west virginia department of environmental protection

## ENGINEERING EVALUATION/FACT SHEET

Application No.:	R13-3495
Plant ID No.:	061-00134
Applicant:	Longview Power LLC
Facility Name:	Longview Power LLC
Location:	Maidsville
NAICS Code:	221112
Application Type:	Construction
Received Date:	June 1, 2020
Engineer Assigned:	Edward S. Andrews, P.E.
Fee Amount:	\$1,000.00
Date Received:	June 1, 2020
Complete Date:	July 29, 2020
Due Date:	October 27, 2020
Applicant Ad Date:	July 17, 2020
Newspaper:	<i>Dominion Post</i>
UTM's:	Easting: 580.6 km      Northing: 4,306.9 km      Zone: 17
Description:	This action is to establish a carbon dioxide emission standard using the Best Standard of Emission Reductions (BSERs) outlined in the Emission Guidelines of 40 CFR 60, Subpart UUUUa for a Pulverized Coal Fired Steam Generating Unit (PC-Boiler).

Figure 3. Diagram of Air Heater

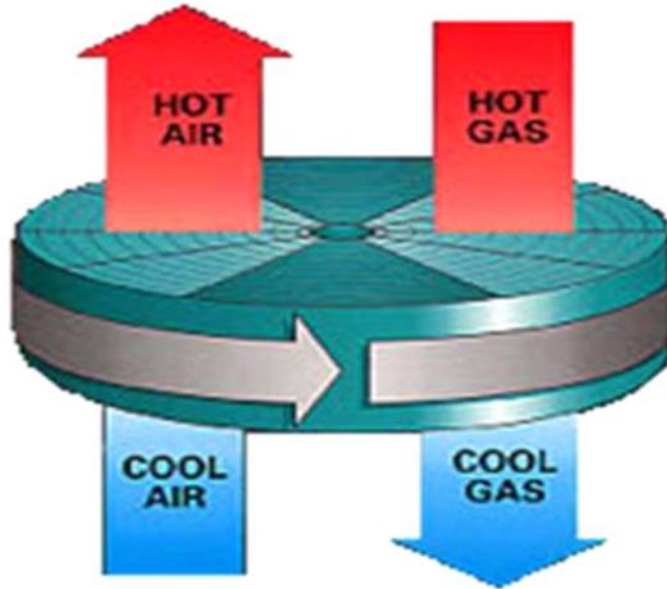
LVP claims that their original air heater seal design meets the intent of the HRI under Subpart UUUUa. The writer agrees with the applicant that the intent of the HRI under Subpart UUUUa was to reduce leakage through the seals and repair ductwork by replacing worn out seals, make improvements to the seal design, using better materials for the seals (i.e. from single to double seals, wear resistance materials, adjustable seals) and repair ductwork. The writer concurs that LVP has implemented the HRI technology in their unit.

Figure 6. Cut-away of Siemens SST-6000 Steam Turbine

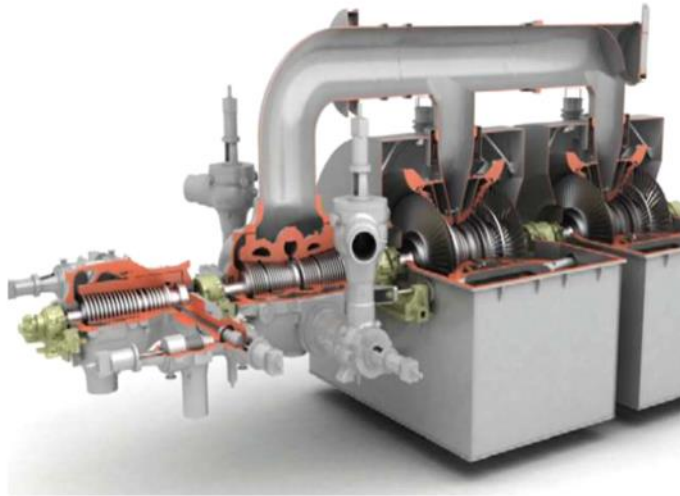
Siemens claims that the SST-6000 package has over a 48% efficiency. As of June 2015, there are 488 units of the SST-6000 package series operating worldwide. Currently, Siemens does not offer any blade path improvement option for the SST-6000 series. Therefore, the blade path upgrade HRI technology is not a feasible option for LVP's SST-6000 turbine package.
